Meeting: Traffic Management Meeting

Subject: Clarence Road area, Leighton Buzzard – Consider

objections to proposed 20mph speed limit

Report of: Basil Jackson

Appendix A - Plan

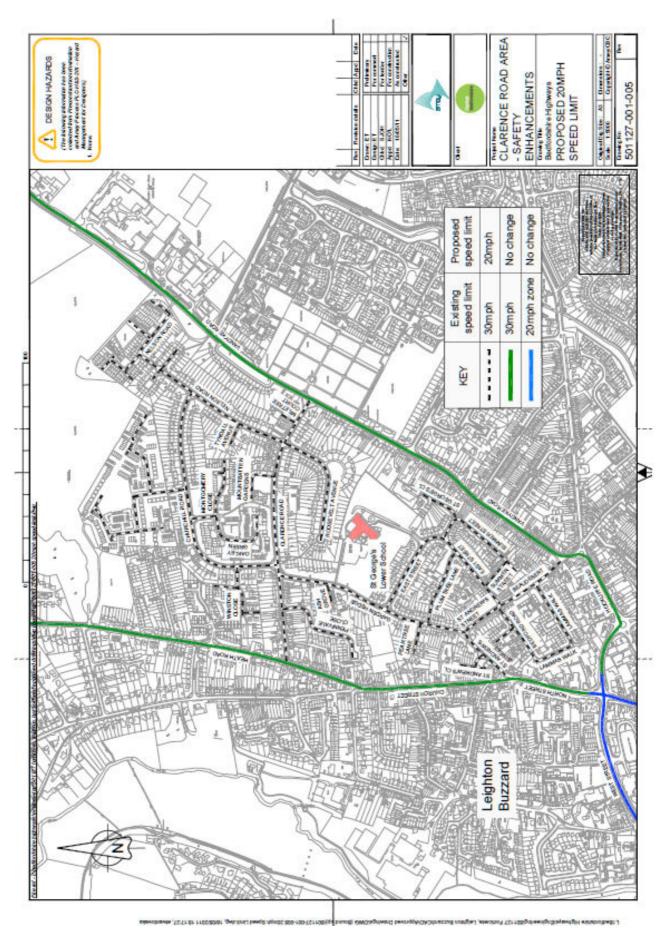
- a) There is no need for slowing traffic down as there are no safety problems or rat-running.
  - b) The proposal will provide unnecessary signs and posts, especially in cul-de-sacs included in the 20mph speed limit area.

- c) Concerns for the use of flat topped road humps as that kind of traffic calming may cause damage to motor vehicles and to buildings; they are also painful for disabled drivers.

- d) The proposal does not include a zebra crossing facility in St Andrews Street where it is more needed than on Clarence Road.

The Police receive complaints of vehicles exceeding the current 30mph speed limit. They consider that more traffic calming measures are needed in order to make the proposed 20mph speed limit self enforcing.

A successful 20 mph speed limit should be generally self enforcing with conditions that cause drivers to naturally travel at around 20 mph. The proposed traffic calming measures are not sufficient to cause the required reduction in vehicle speeds on the roads subject of this proposal, consequently without additional engineering measures this proposed 20 mph speed limit is unlikely to be complied with.

- b) It is acknowledged that some roads included in the proposed 20mph speed limit area are cul-de-sacs or narrow, heavily parked, residential roads where the existing speed is low. Their inclusion in the 20 mph area is therefore automatic. If the culs-de-sac were not included within the 20mph limit area, additional signs would be required which would increase the cost and add extra street clutter.

- c) Minimal vertical traffic calming features have been proposed in order to target the roads with the highest speeds and road safety problems. National guidance has been followed and flat topped road humps have been considered the most appropriate features at those locations. The flat topped humps have been designed to have shallow ramps to minimise discomfort for vehicle drivers. As there is an existing 7.5tonne weight restriction in place, very few large vehicles pass through this area, therefore the possible vibration and likelihood of resulting damage, would be very low.

- d) The proposed zebra crossing on Clarence Road is located on the pedestrian desire line to the local shops from the new development and the funding for it was allocated in Highways Act Section 106 relating to that development. During the public exhibition a number of residents (especially elderly people) expressed their concerns about safety when crossing in that location and requested a controlled crossing. The personal injury collision data shows the site will benefit from the provision of a zebra crossing. The request for a zebra crossing on St Andrews Street can be considered as a separate matter.

A decision was made by the local Central Bedfordshire Councillors not to implement schemes involving large numbers of vertical traffic calming features. This is why only isolated raised tables and crossings are proposed. The speed survey shows that the 85<sup>th</sup> percentile traffic speeds on most of the roads in the proposed 20mph area are below the existing 30mph speed limit and often below 25mph. Traffic calming features (miniroundabouts, road narrowings, raised zebra, raised junction and tables) have been proposed only on roads with higher speeds. It is also anticipated, based on experience, that the introduction of a 20mph limit together with road markings and regular repeater signs will lower the traffic speed by a few mph. Therefore it is considered that the proposed speed limit should be mostly self enforcing.
